Historic District Commission
Certificate of Approval

Plans for 41 Buffalo
Property address

Owner Mr. & Mrs. R. Elias

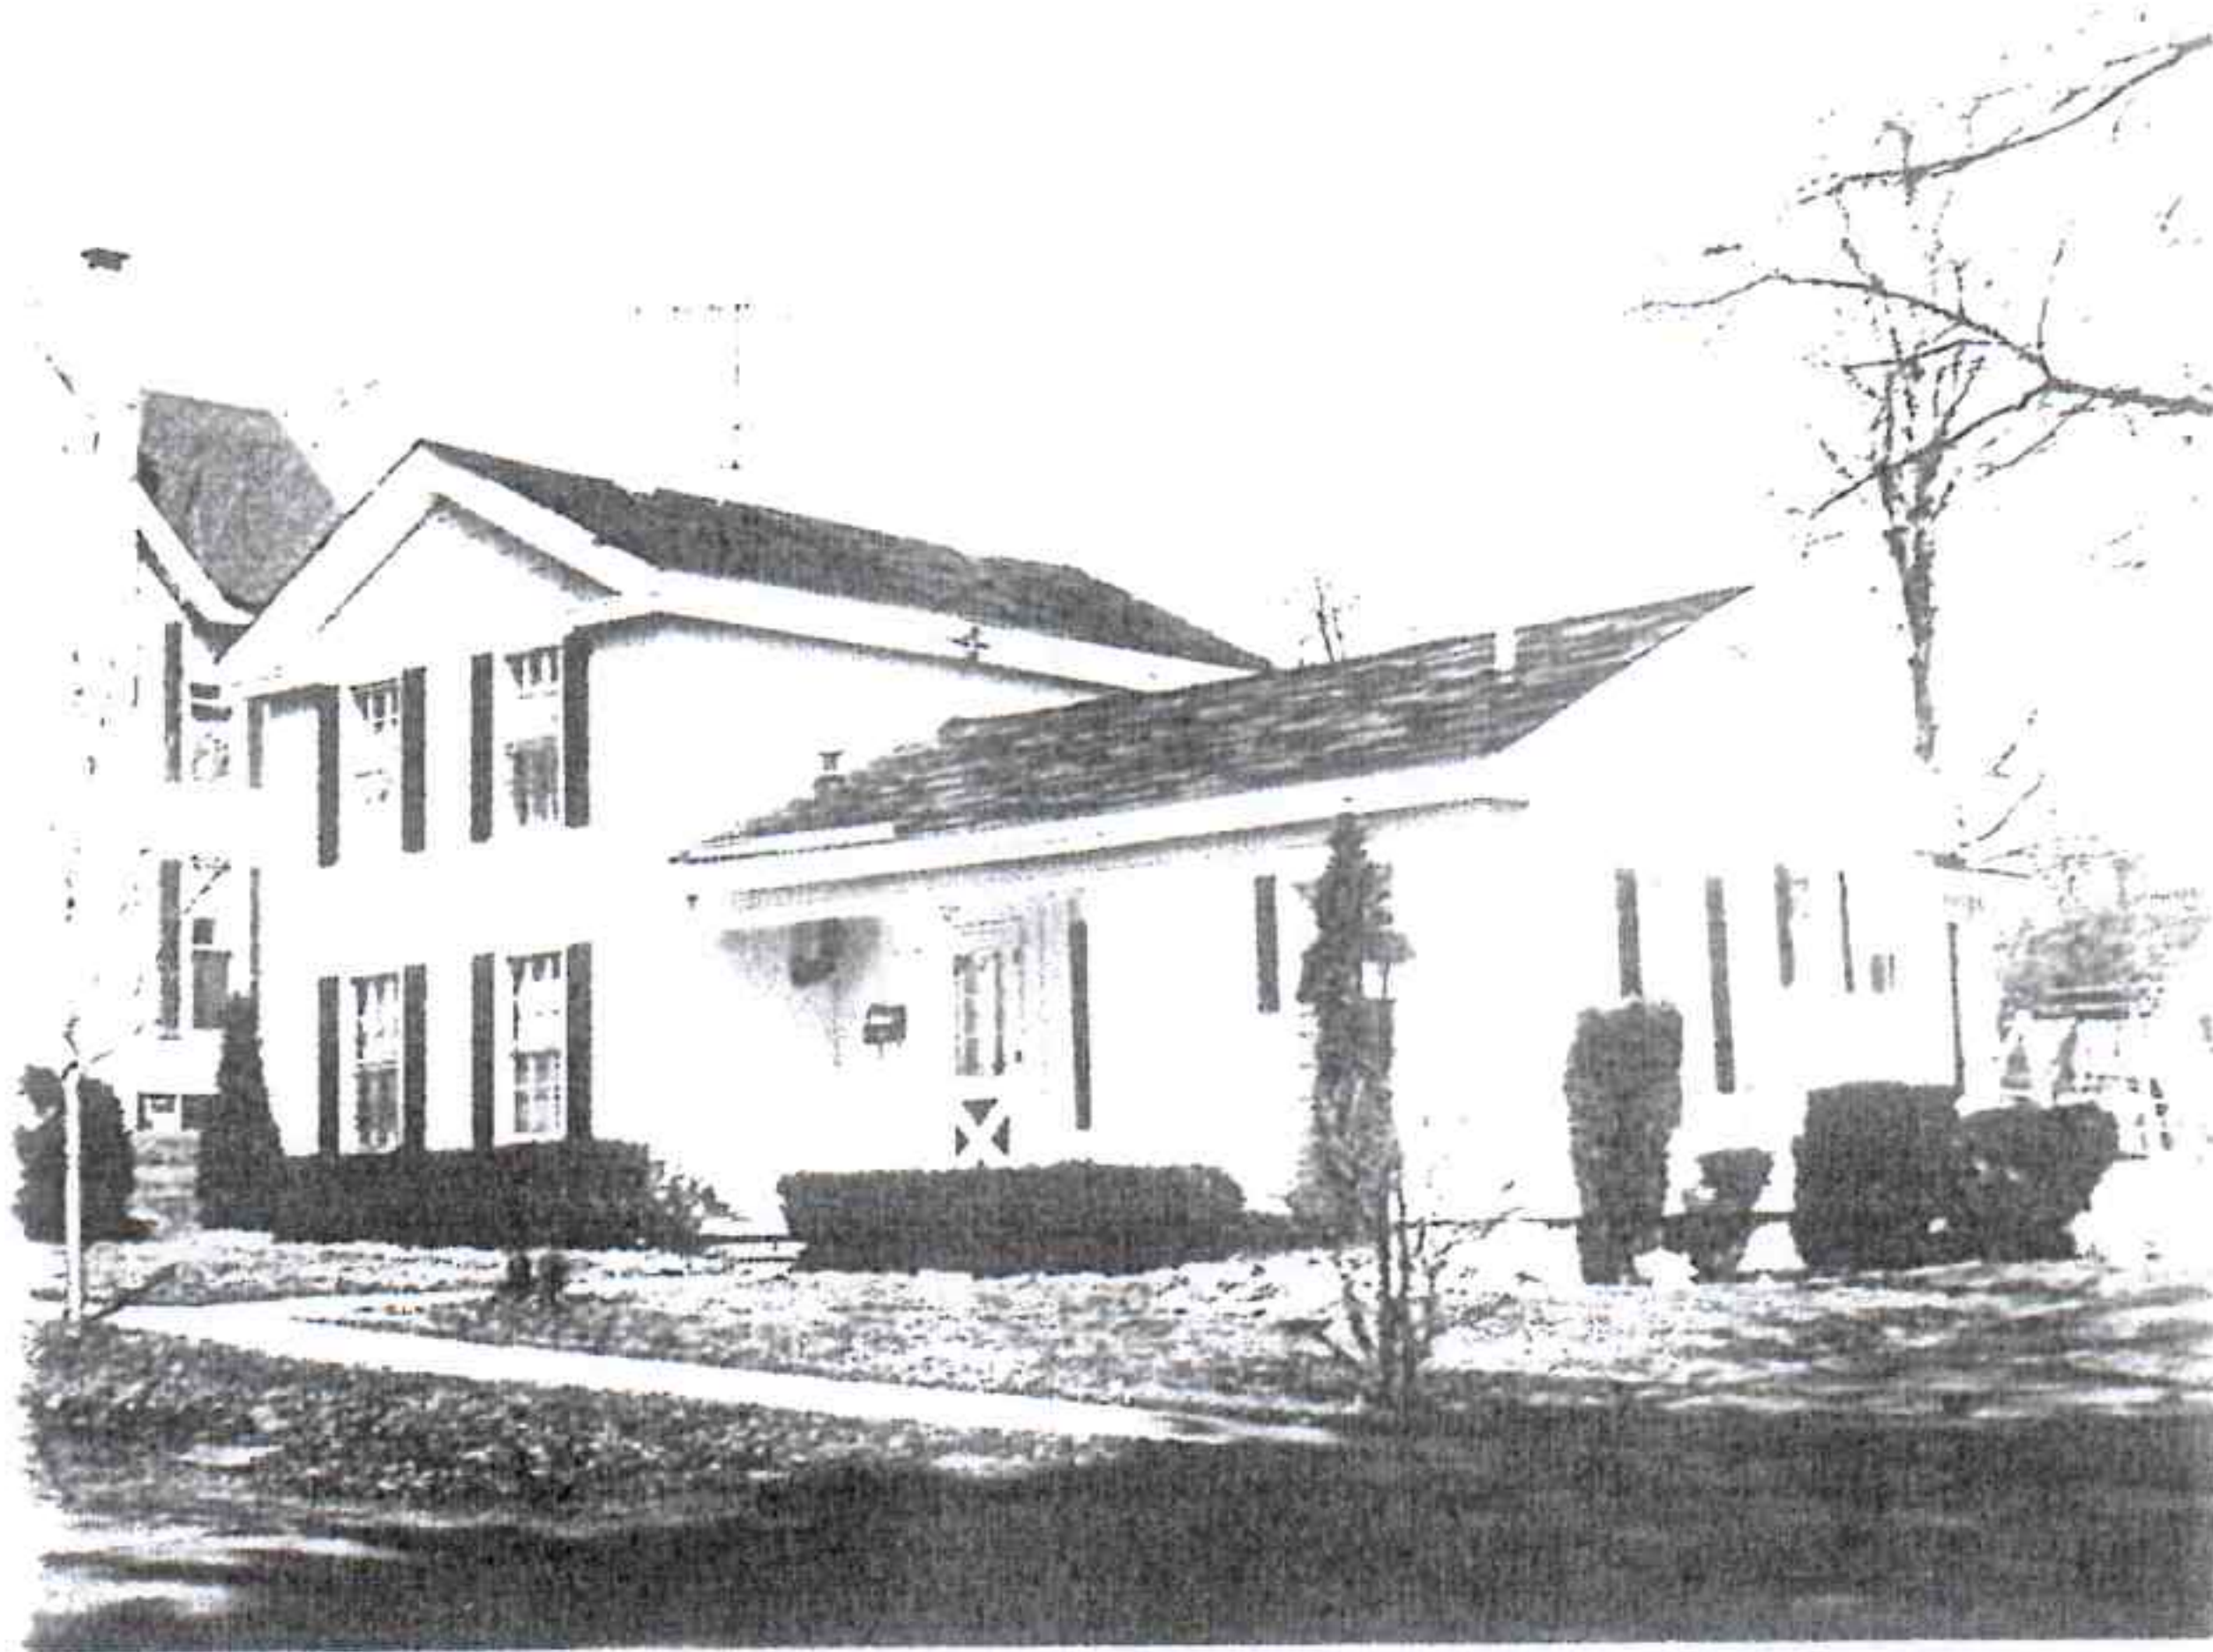
Recommendation: that the window (north facade) in new construction be changed to 2 double-hung windows (of the same size as that shown) butted together & centered on the wall, & to be hung at the same height as the existing windows. Also, the Commission recommends the addition of a window in the new construction on the south facade to the right of the door shown on the drawing.
